## **11.0 PLANT SYSTEMS**

### **11.4 VENTILATION AND CONFINEMENT SYSTEMS**

#### **11.4.1 CONDUCT OF REVIEW**

**Figure 11.4-1, Ventilation Confinement Zones**

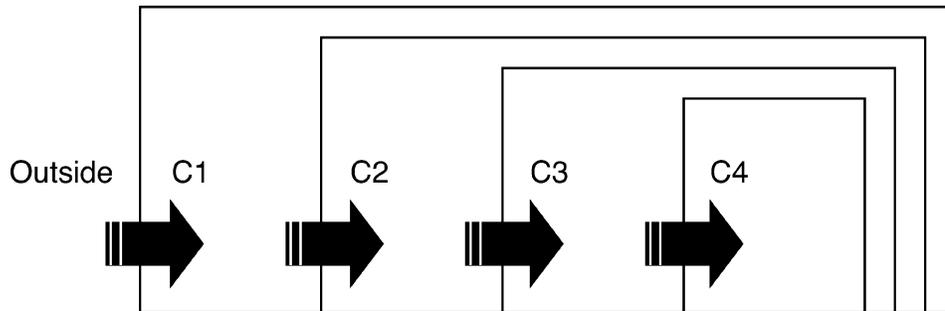
- Ventilation zones operated at pressure differentials designed such that air leakage occurs from areas of low radiation hazard into areas with the greater radiation hazard (Reference 11.4.3.15, Section 11.4.1.2). See Figure 11.4-1.
